HISTORIC AND DESIGN REVIEW COMMISSION

June 19, 2019

HDRC CASE NO: 2019-343
ADDRESS: 414 DONALDSON AVE
LEGAL DESCRIPTION: NCB 1932 BLK 39 LOT 26 AND 27
ZONING: R-6,H
CITY COUNCIL DIST.: 7
DISTRICT: Monticello Park Historic District
APPLICANT: KKW Donaldson
OWNER: San Antonio San Antonio/KKW Donaldson
TYPE OF WORK: Window replacement, painting brick, replace siding
APPLICATION RECEIVED: May 22, 2019
60-DAY REVIEW: July 21, 2019
CASE MANAGER: Stephanie Phillips
REQUEST:

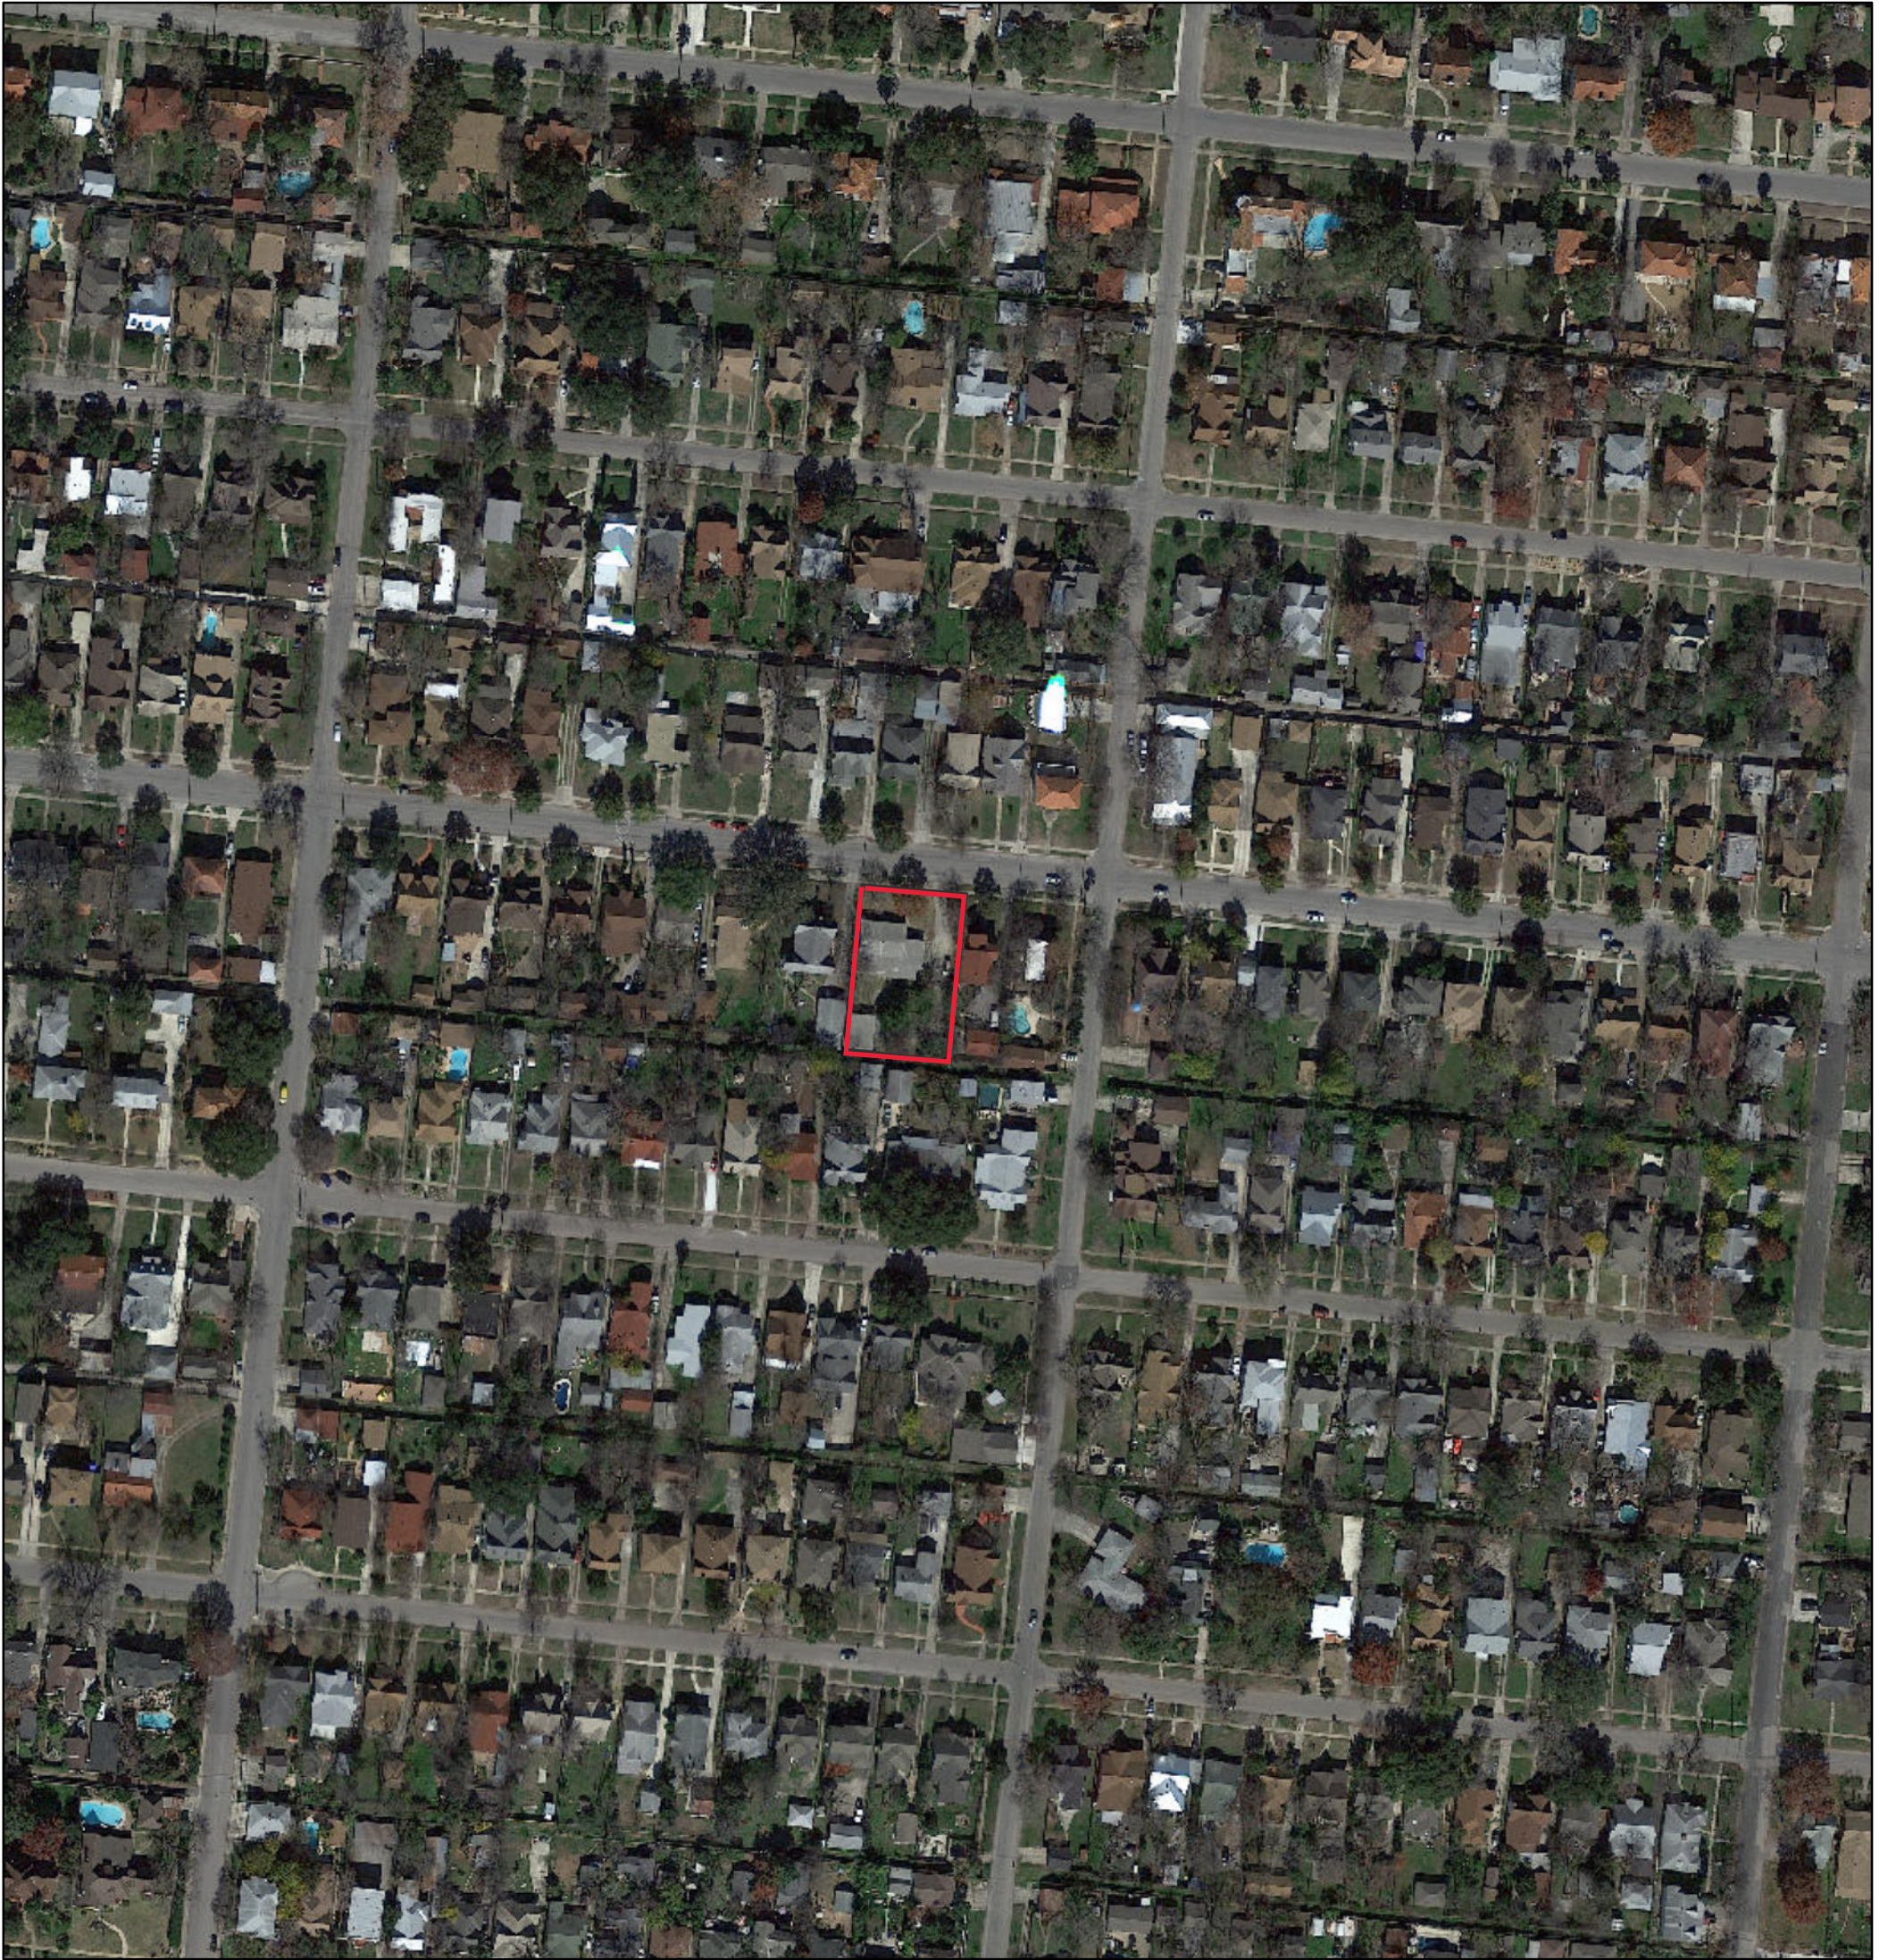
Item 3, Staff recommends approval of the window replacement based on finding d with the following stipulation:

- i. That the window size matches the existing opening and configuration. The applicant is required to submit an updated window specification to staff with dimensions for review and approval.

Paint exterior (Minor Alteration, Continued), Methodology

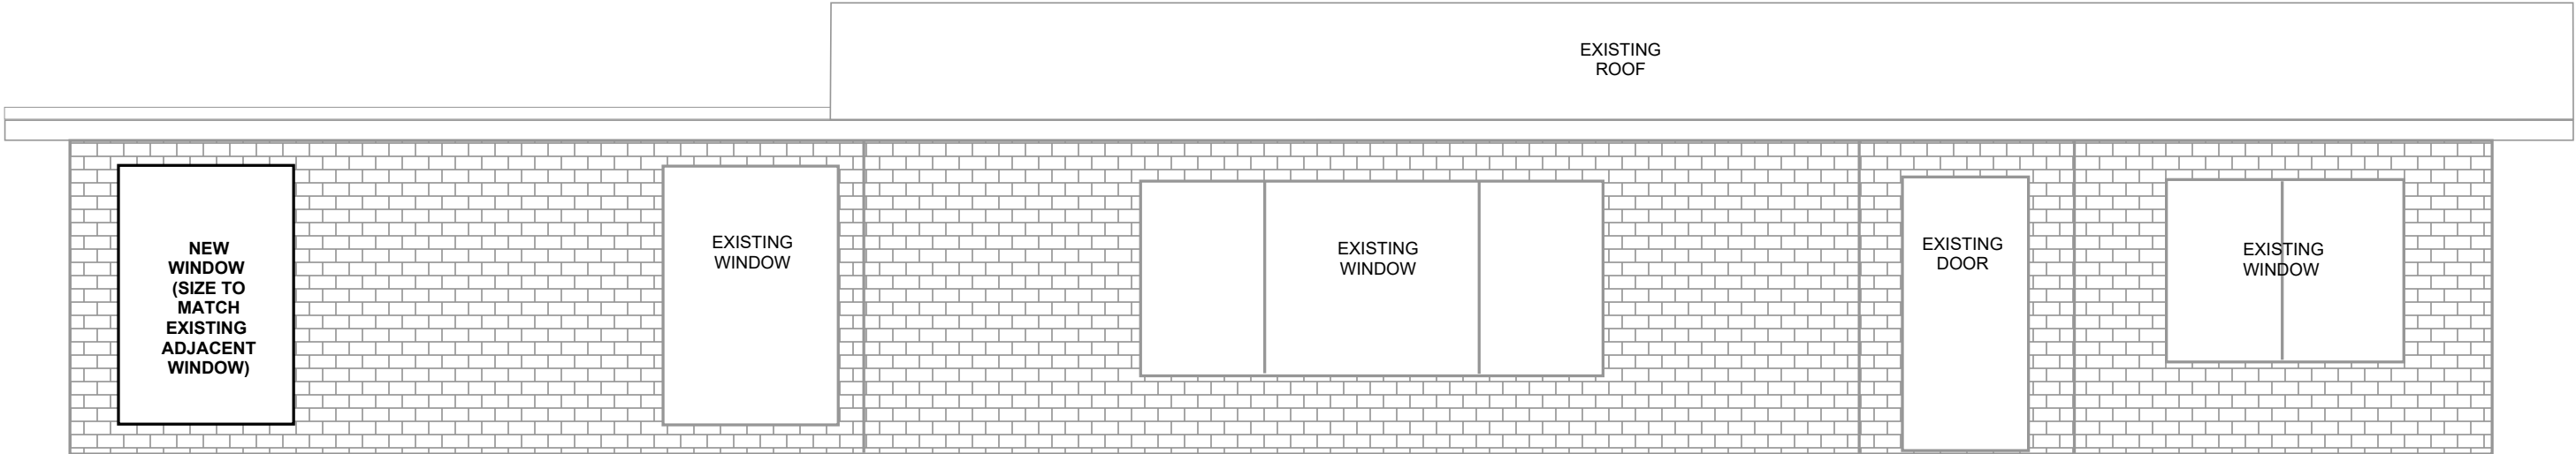
- g. BRICK PAINTING – The applicant is requesting approval to paint the brick façade of the structure. The original brick, a rusty red color, is exposed. According to the Secretary of the Interior’s Standards for Rehabilitation, historically unpainted brick should not be painted. Brick structures built prior to the 1870s were largely constructed of handmade bricks, which were generally softer, more porous, and weaker than bricks made at the turn of the 20th century. These handmade bricks were frequently painted or coated because the strength of the brick was insufficient without a coating for stabilization. However, as machine-made bricks became the norm during the latter half of the 19th century, bricks became inherently stronger and did not require paint or coatings for protection and strength. These bricks commonly featured harder “dress” surfaces, which were meant to face the exterior of the structure and remain unpainted. 414 Donaldson was constructed in the early 1950s and was historically unpainted. Painting historically unpainted brick on structures of this era can lead to trapped water in the porous material, eventually destroying the brick due to the damaging effects of water infiltration and freeze-thaw cycles. Unpainted brick of this era is inherently high strength and low-maintenance on its own. Once these structures are painted, consistent repainting is required to maintain the aesthetics of the brick. Per the Guidelines for Exterior Maintenance and Alterations, 2.B., surfaces that were historically unpainted should not be painted. Staff does not find the painting of the façade to be appropriate.

Item 6, Staff does not recommend approval of painting the exterior brick based on finding g.
